Access Compliance Report

Public Rights-of-Way

Intersection ID: 47904	Main Street: CAMP_VERDE_LN	Cross Street: ROUND_ROCK_RD	Location: NW
ADA ID: 33F918E465D5	Ramp Type: Perp	Initial Pass/Fail: Fail	Overall Compliance: No
Severity Score: 8.75			
Codes/Mitigation Info/Possible Solution		Field Measurements/Component Compliance

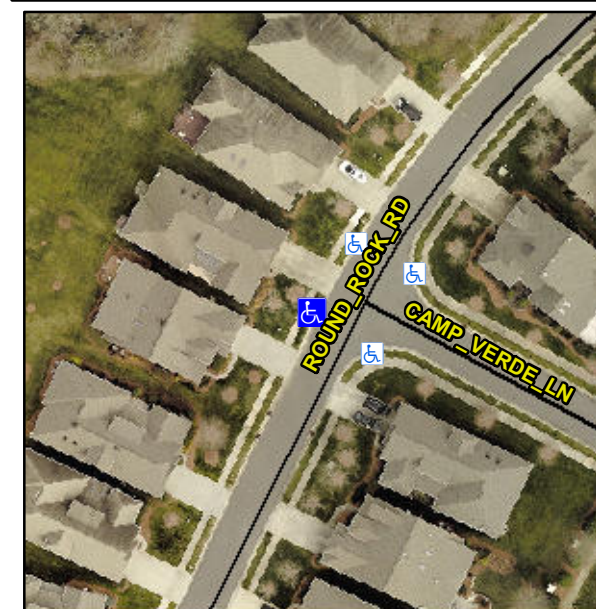
Not Found, R304.5.1

Compliance	Description	Data	Compliance	Description	Data
N/A	Ramp Length (in)	46.0	Yes	Ramp Slope (%)	6.8
No	Ramp Width (in)	46.5	Yes	Ramp XSlope (%)	1.6
N/A	Flare Type LT	N/A	N/A	Flare Type RT	N/A
N/A	Flare Slope LT (%)	N/A	N/A	Flare Slope RT (%)	N/A
N/A	Flare Traversable LT?	N/A	N/A	Flare Traversable RT?	N/A
N/A	Landing Length (in)	N/A	N/A	DWS Provided?	N/A
N/A	Landing Width (in)	N/A	N/A	DWS Contrast?	N/A
N/A	Landing Slope (%)	N/A	N/A	DWS Length (in)	N/A
N/A	Landing X Slope (%)	N/A	N/A	DWS Full Width?	N/A
N/A	Landing Curb? (Y/N)	N/A	N/A	DWS Offset (in)	N/A
N/A	Shared Landing?	N/A			
N/A	Gutter Ponding?	N/A	N/A	Gutter Slope (%)	N/A
N/A	Gutter Lip Ht (in)	N/A	N/A	Gutter X Slope (%)	N/A
N/A	Painted X Walk1?	No	N/A	Painted X Walk2?	N/A
	X Walk 1 Direction	To SE		X Walk 2 Direction	N/A
N/A	X Walk 1 Width (in)	N/A	N/A	X Walk 2 Width (in)	N/A
	X Walk 1 Slope (%)	2.1		X Walk 2 Slope (%)	N/A
	X Walk 1 X Slope (%)	1.6		X Walk 2 X Slope (%)	N/A

Remove & Replace Entire Ramp.
